# Access Compliance Report

## Public Rights-of-Way

### (Curb Ramps)

Intersection ID: 14401	Main Street: BAXTER_ST	Cross Street: BALDWIN_AV	Location: E
ADA ID: 49B1A9C0B965	Ramp Type: PerpDiag	Initial Pass/Fail: Fail	Overall Compliance: No
			Severity Score: 13.75

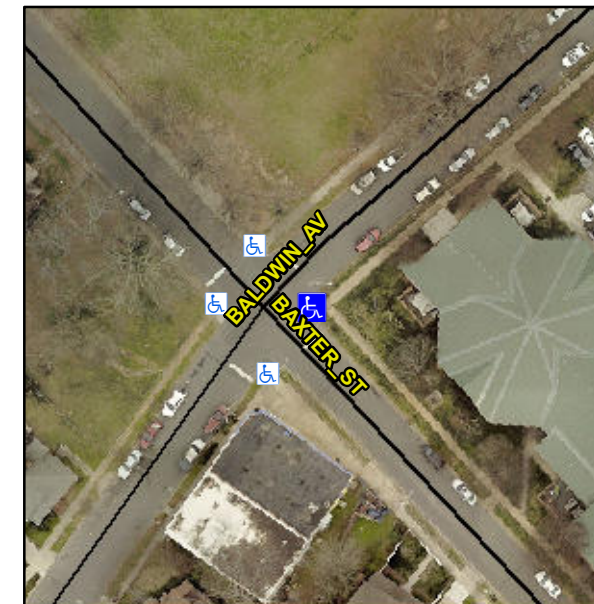
**R304.2.2, R304.5.3**

Compliance	Description	Data	Compliance	Description	Data
N/A	Ramp Length (in)	36.0	No	Ramp Slope (%)	8.4
Yes	Ramp Width (in)	48.0	No	Ramp XSlope (%)	3.2
N/A	Flare Type LT	N/A	N/A	Flare Type RT	N/A
N/A	Flare Slope LT (%)	N/A	N/A	Flare Slope RT (%)	N/A
N/A	Flare Traversable LT?	N/A	N/A	Flare Traversable RT?	N/A
N/A	Landing Length (in)	N/A	N/A	DWS Provided?	N/A
N/A	Landing Width (in)	N/A	N/A	DWS Contrast?	N/A
N/A	Landing Slope (%)	N/A	N/A	DWS Length (in)	N/A
N/A	Landing X Slope (%)	N/A	N/A	DWS Full Width?	N/A
N/A	Landing Curb? (Y/N)	N/A	N/A	DWS Offset (in)	N/A
N/A	Shared Landing?	N/A			
N/A	Gutter Ponding?	N/A	N/A	Gutter Slope (%)	N/A
N/A	Gutter Lip Ht (in)	N/A	N/A	Gutter X Slope (%)	N/A
N/A	Painted X Walk1?	No	N/A	Painted X Walk2?	No
	X Walk 1 Direction	To NW		X Walk 2 Direction	To SW
N/A	X Walk 1 Width (in)	N/A	N/A	X Walk 2 Width (in)	N/A
	X Walk 1 Slope (%)	3.0		X Walk 2 Slope (%)	0.6
	X Walk 1 X Slope (%)	0.2		X Walk 2 X Slope (%)	2.9

N/A	Ramp inside XWalk1?	N/A	N/A	Ramp inside XWalk2?	N/A
	Road Slope (%)	2.5	N/A	Clear Space?	N/A
	Road X Slope (%)	5.0	N/A	Clear Space to XWalk (in)	N/A
N/A	Any Obstructions?	N/A	N/A	Storm Grate/Utility Hazard?	N/A
	Obstruction Type			Storm Grate/Utility Type	
		N/A			N/A
			Yes	Surface Condition? (G/P)	Good

**Remove & Replace Curb Ramp With Two New Directional Ramps or Equivalent.**
